Appendix 15-4- Road Safety Audit (RSA)

24032-02-001

PROPOSED WINDFARM DEVELOPMENT AT DERRYADD, CO. LONGFORD.

Road Safety Audit Stage 1

2.2 **Problem:** Water Ditch Works

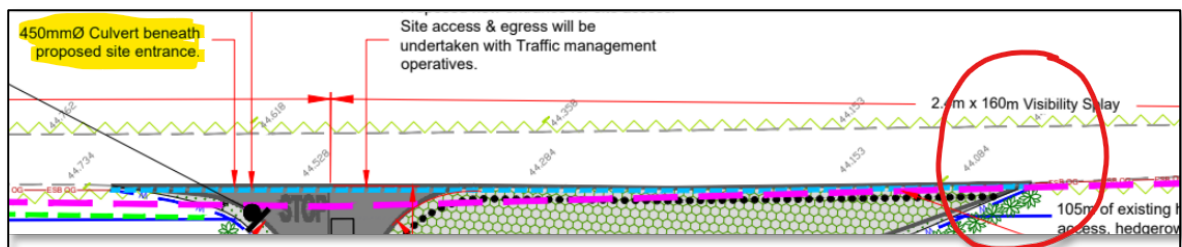
An existing watercourse runs parallel to the R392. At the time of the audit, there was a large volume of water in the drain. The design drawing indicates that a culvert will be installed under the site access. This may result in a culvert headwall being constructed within the clearzone on the western approach to the site access. An errant vehicle leaving the road may collide with the culvert headwall.

Ensure any roadside drainage works within the clearzone for an 80kph road are compliant with the relevant design standards. Provide appropriate mitigation measures if applicable.

2.2	Yes	No	No headwall is required within clearzone nor is any new hazards being created.	Yes
2.3	Yes	Yes	-----	-----
2.4	Yes	Yes	-----	-----
2.5	Yes	No	Lands are not within the red line boundary of the scheme .Client will liaise with LA to include the vegetation as part of the annual maintenance.	Yes

2.3 **Problem:** Visibility Splays

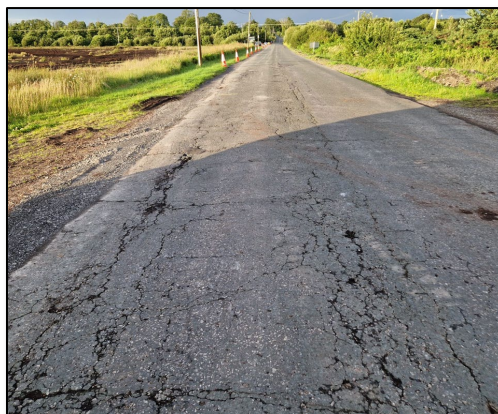
The design drawings indicate that some existing hedgerows are to be set-back for visibility when exiting the site while other sections are to be retained. A lack of a programme of maintenance, issues of ownership of the boundary and regrowth over time may result in the visibility splays being reduced. This may contribute to collisions at the junction when vehicles are exiting the site.

Ensure adequate visibility splays are provided and maintained. Remove the hedge/verge boundary for the extents of the visibility splays.

Title:
**SITE ACCESS A - R392
AUTOTRACK ASSESSMENT,
SIGHT ENTRANCE DETAILS &
VISIBILITY SIGHTLINES**

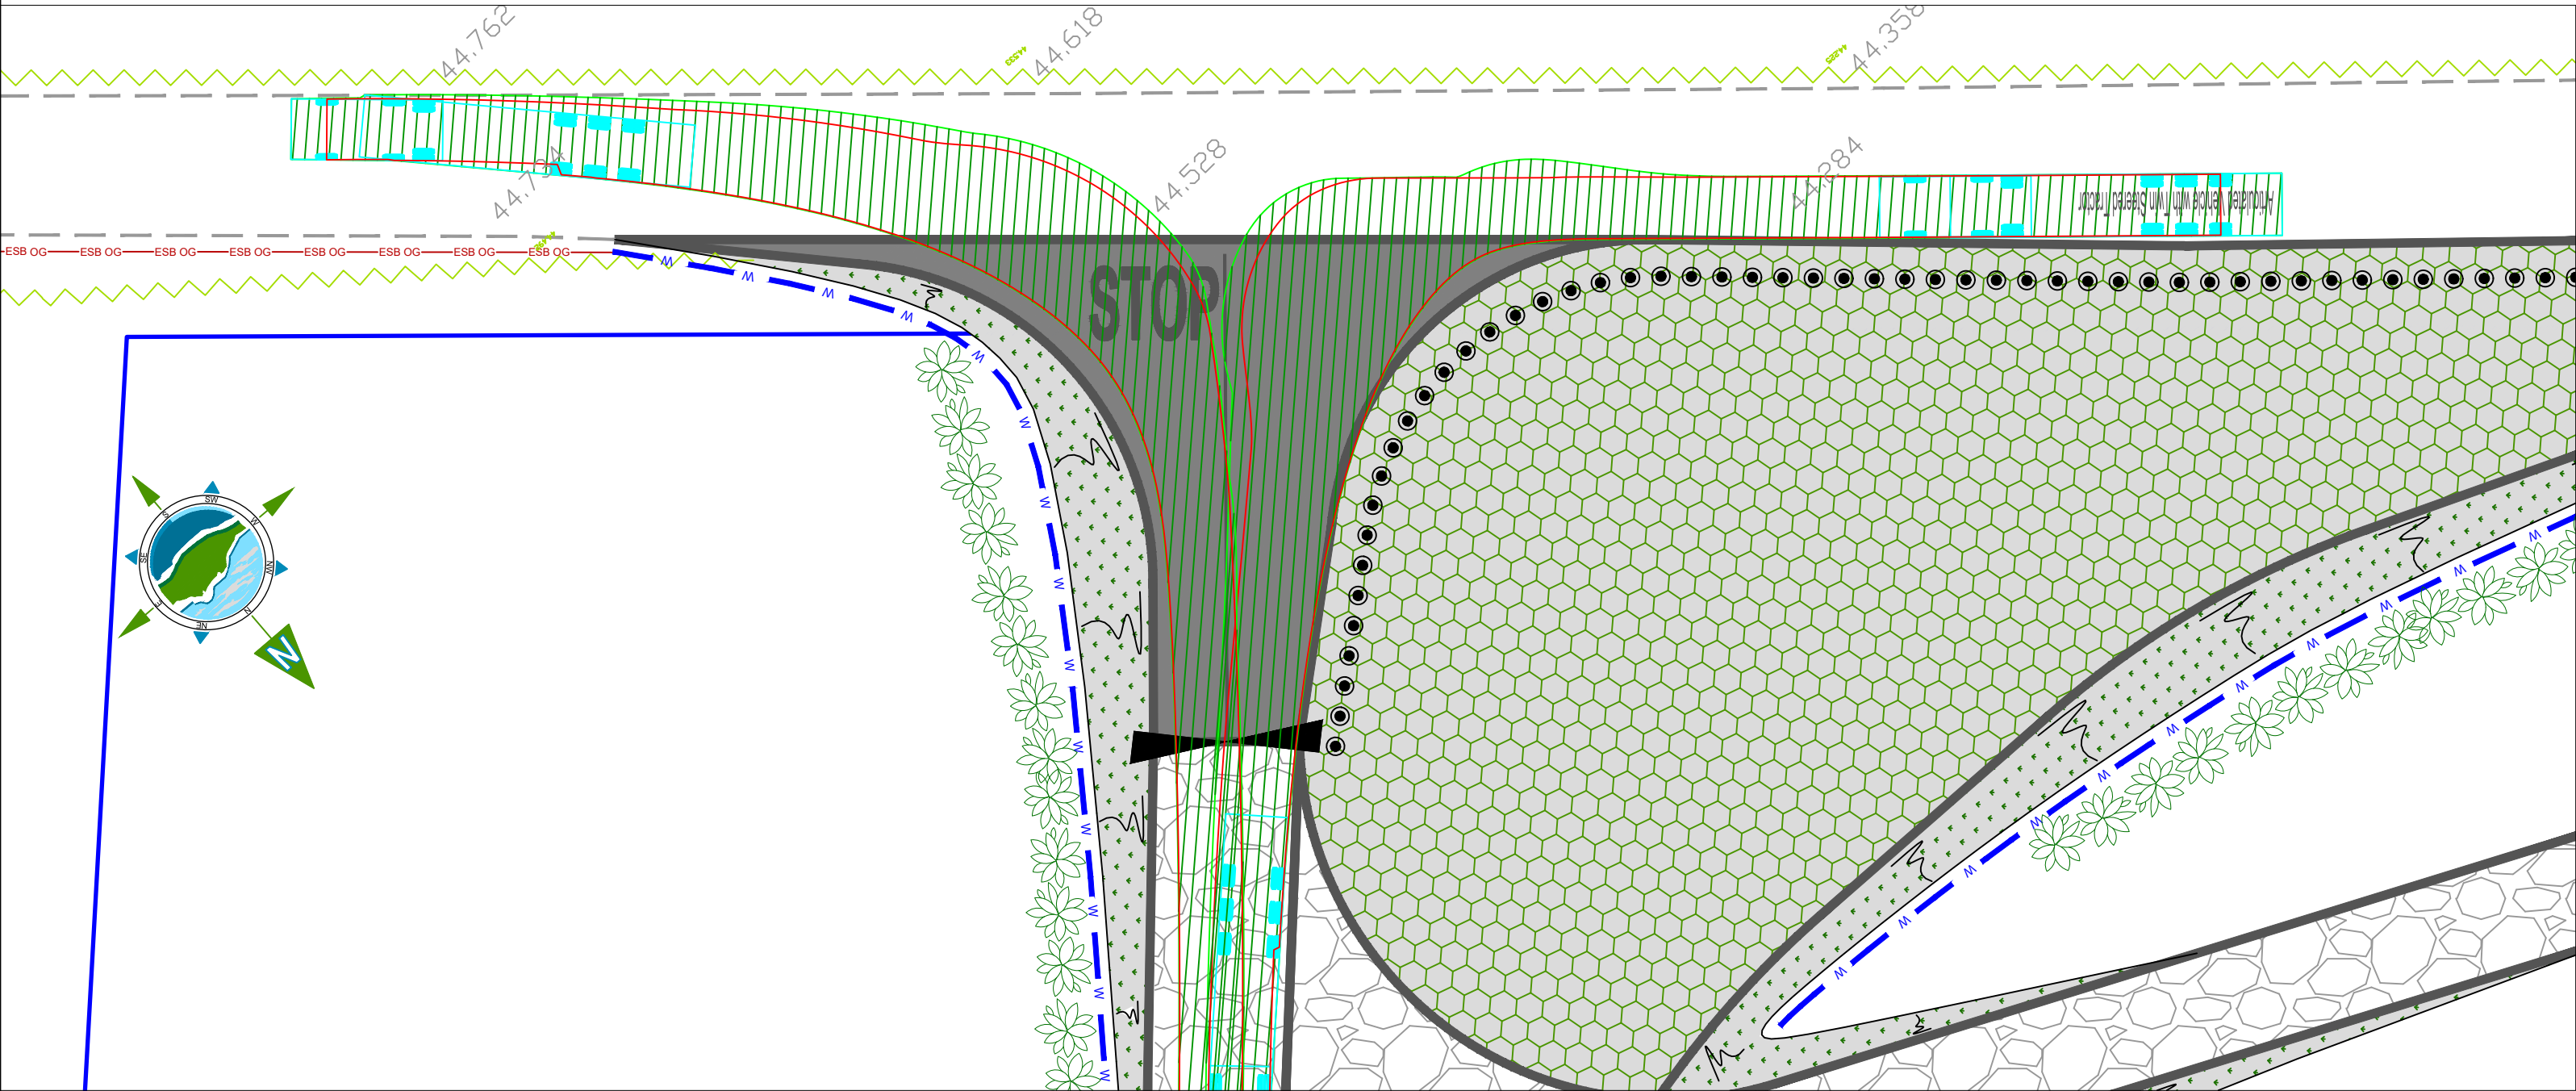
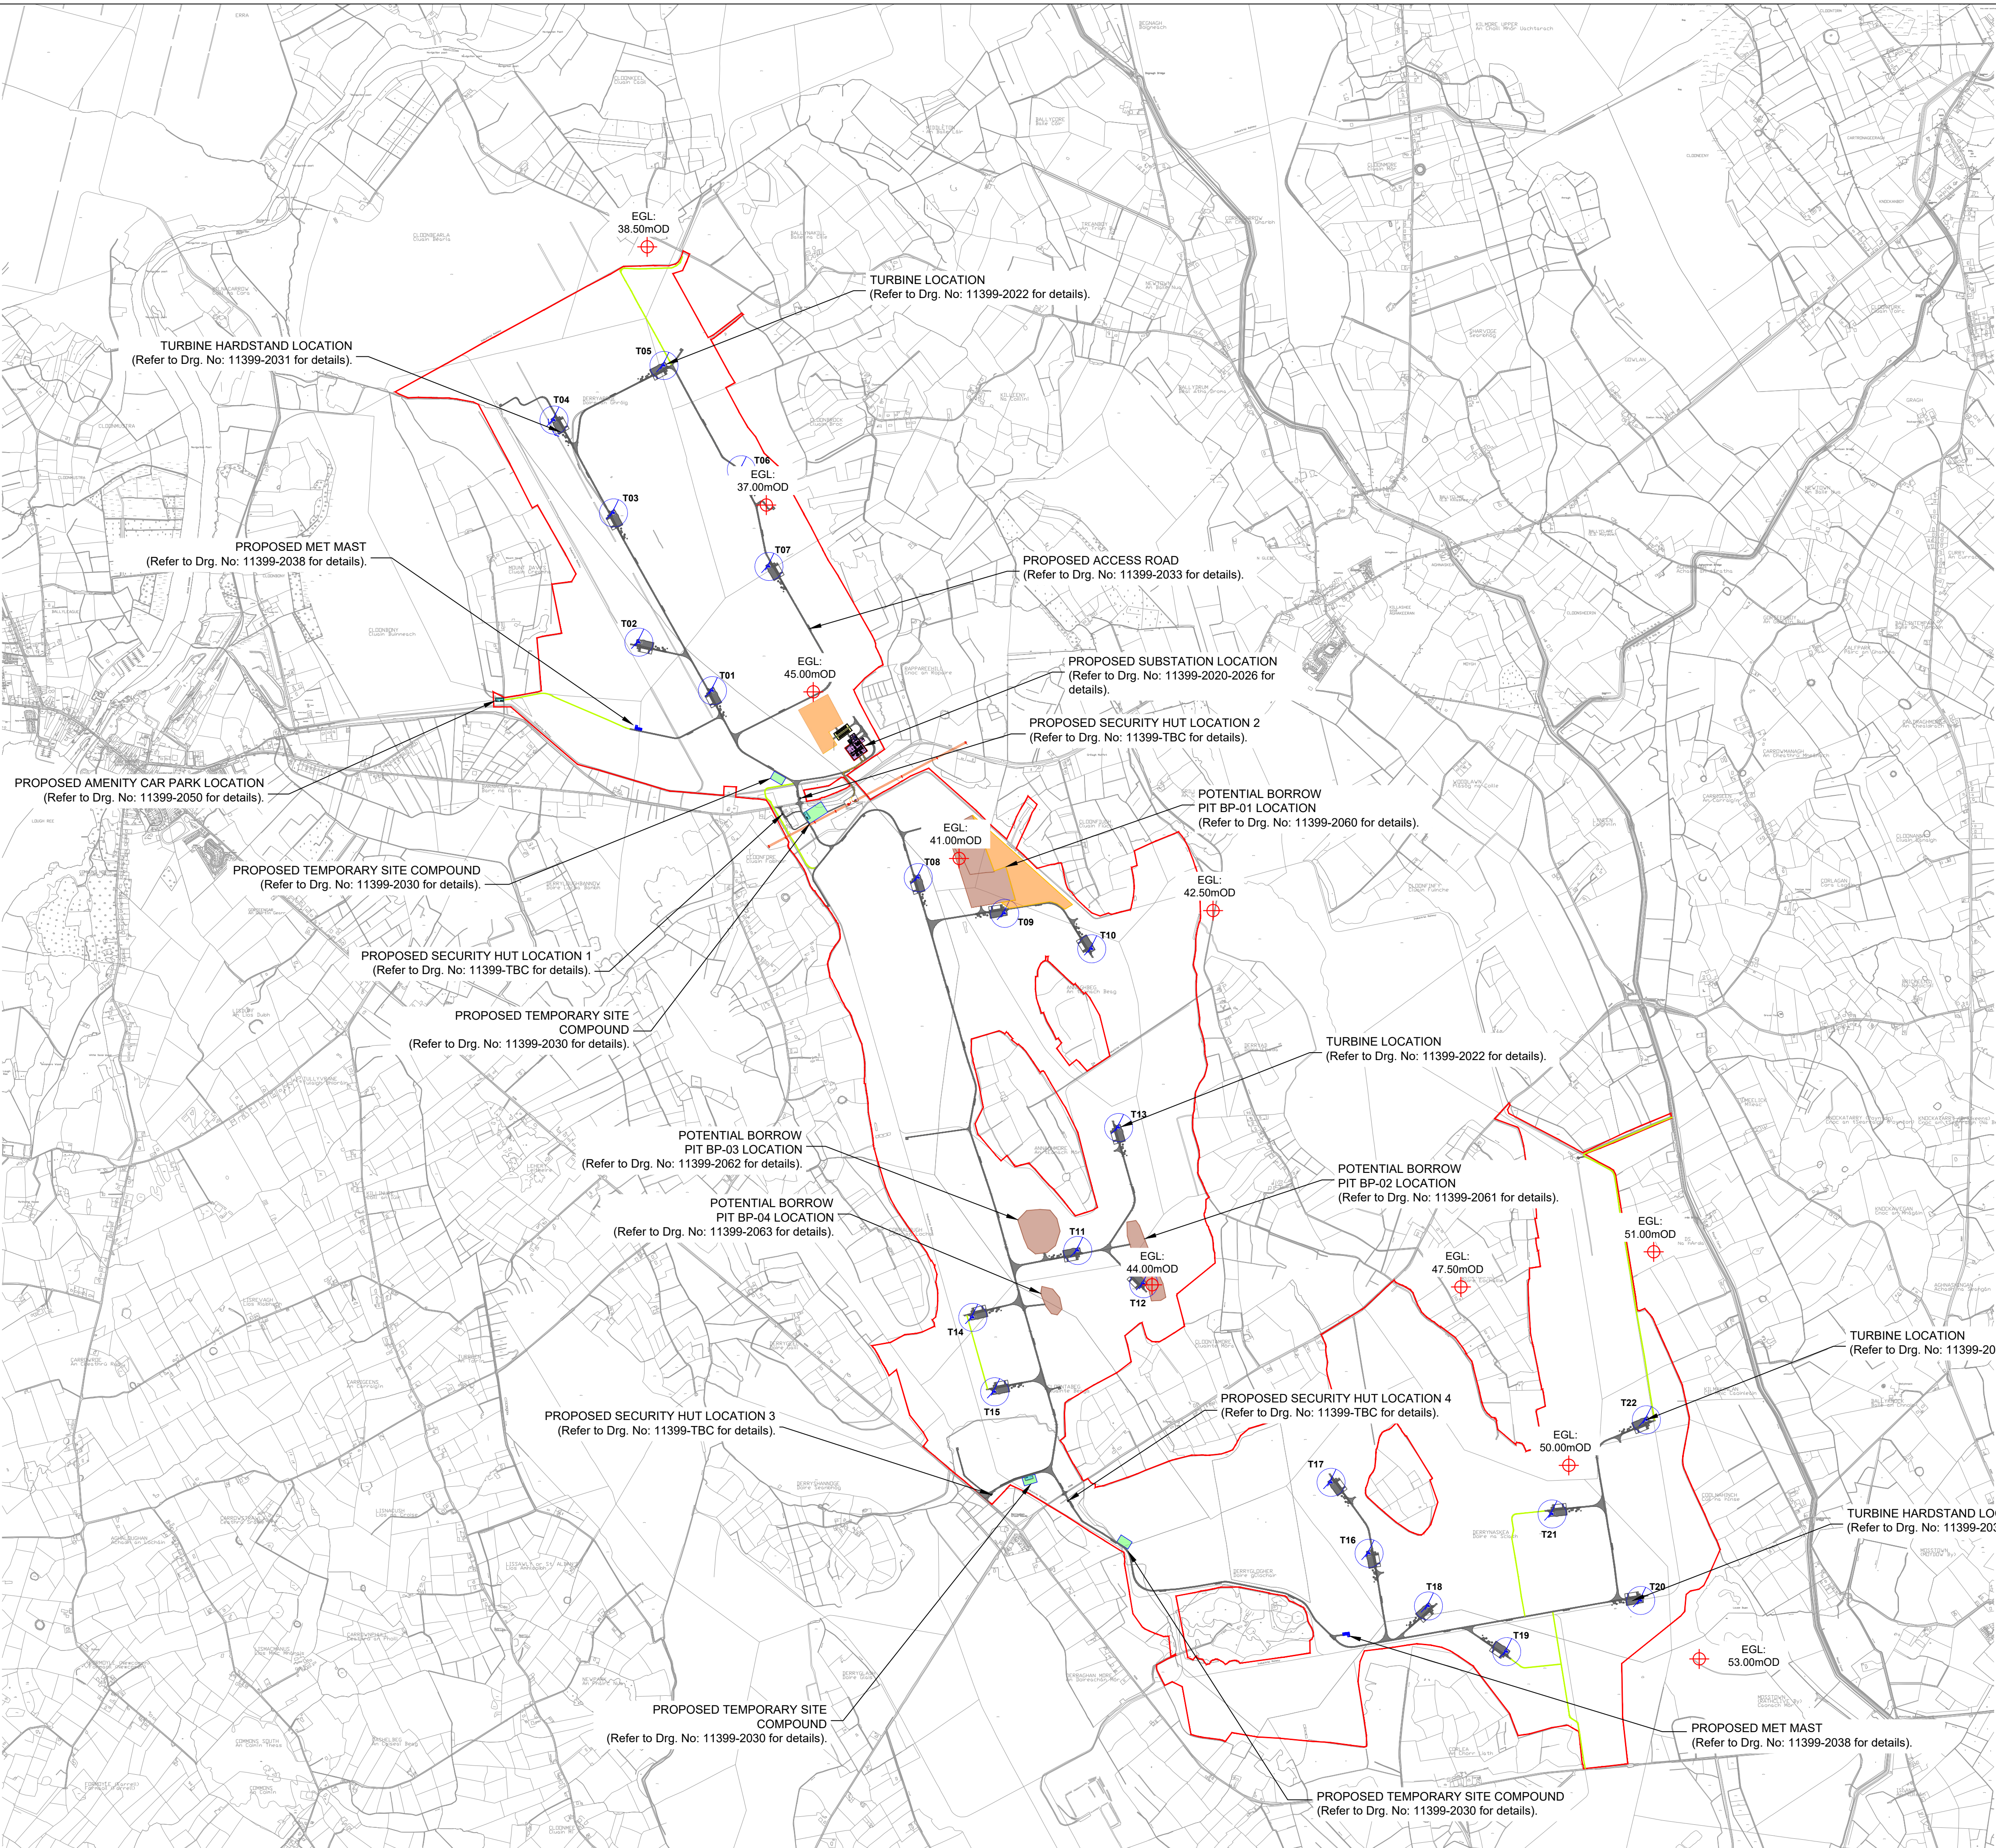
The design drawings indicate existing hedgerows to be trimmed and maintained for visibility when exiting the site. A lack of a programme of maintenance, issues of ownership of the boundary and regrowth over time may result in the visibility splays being reduced. This may contribute to collisions at the junction when vehicles are exiting the site.

Ensure adequate visibility splays are provided and maintained. Remove the hedge/verge boundary for the extents of the visibility splays.

2.1	Yes	No	Hedgerow on clients land is being set back. Hedgerow on third party land is to be trimmed and maintained as per programme of maintenance agreement between client and landowner.	Yes
